New Product Release

07/05

Ford just flipped its lid . . . inner lid, that is.

Recessed Plastic Inner Lid
W3BPD

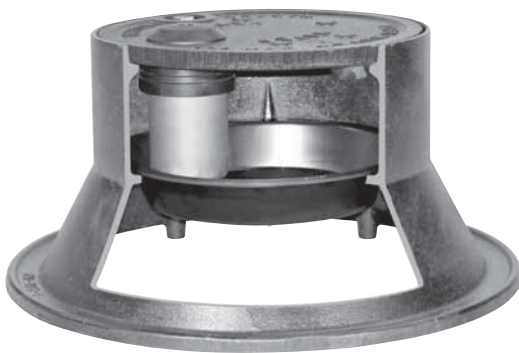
Ford's Wabash Double Lid Covers having a 11-1/2" lid size, with an E-read option, will now have the W3BPD recessed inner lid as the standard inner lid at *no additional charge*. The 2" recessed plastic inner lid provides frost protection and allows up to six inches of space for installation of a transmitting device. This change only affects the W3, W4, W31, W32 and W3H covers with the E-read option.

Plastic Inner Lid
W3BP (Flat Style)

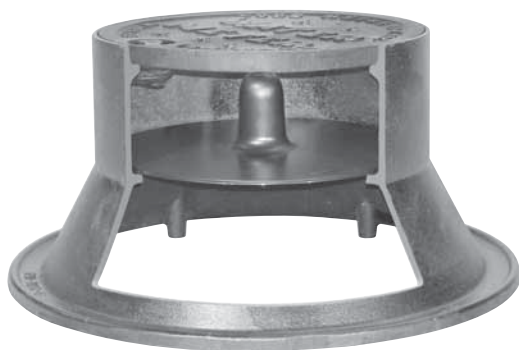
Wabash covers with 11-1/2" lid size without the E-read option will continue to have the W3BP flat style, inner lid. To order covers with the W3BPD recessed plastic inner lid option, without the E-read option add "-D" to the catalog number. Example: W3-D
